URBAN DESIGN COMMISSION APPLICATION CITY OF MADISON

Project Name: the Galaxie Phase I

Purpose: UDC Design Progression Submission

DESIGN PROGRESSION ITEMS:

PLANTER AND GLASS RAILING DETAILS

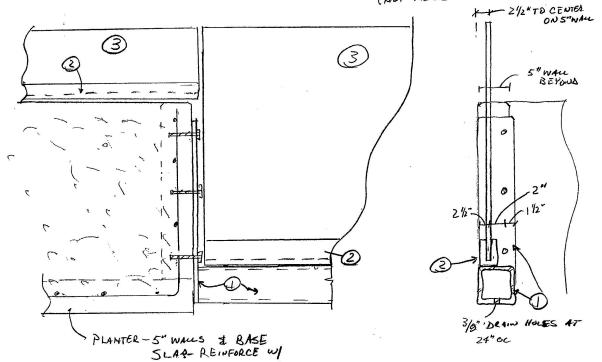
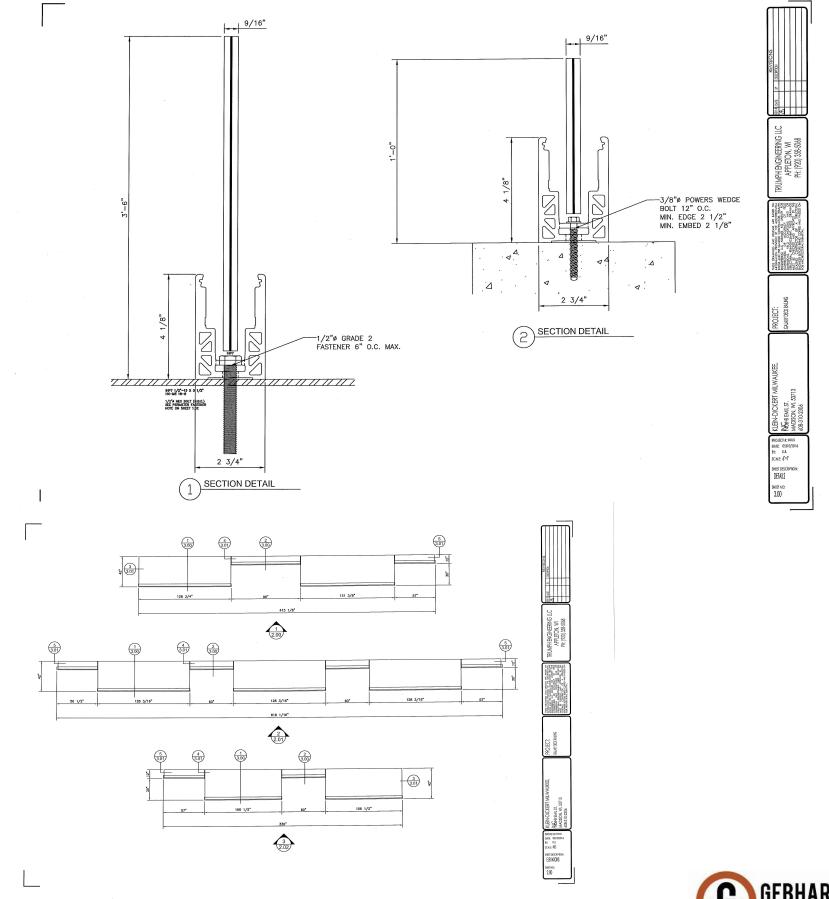
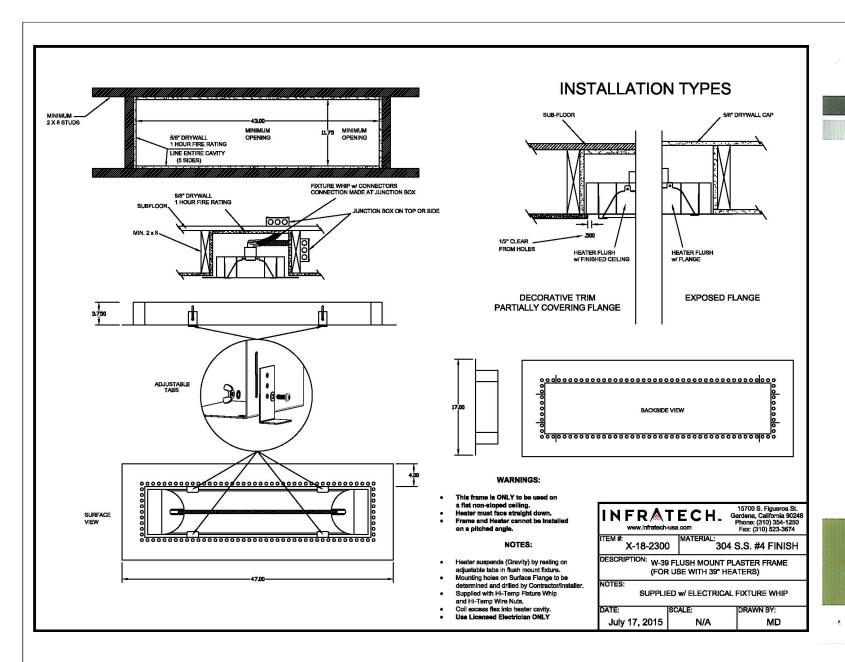
2. 14th floor unit balcony revisions: railing, planters, & canopy

The building owner would like to convert the flat roof area outside the most southeastern 2-story unit on the 14th floor of the Phase I tower to a roof terrace/balcony for use by the tenant of the unit. The roof area is currently a fully adhered EPDM membrane, and is approximately 750 sq. ft. The proposed design is comprised of the following:

1. Concrete planter and glass railing system

2. Solid canopy and pergola over seating area and fireplace

The proposed design seeks to keep the existing roof intact and utilize the concrete planters as ballast to resist the wind loads imposed on the glass railing. The railing design utilizes base and edge clips that will result the glass panels dissolving into the top of the building and sky.
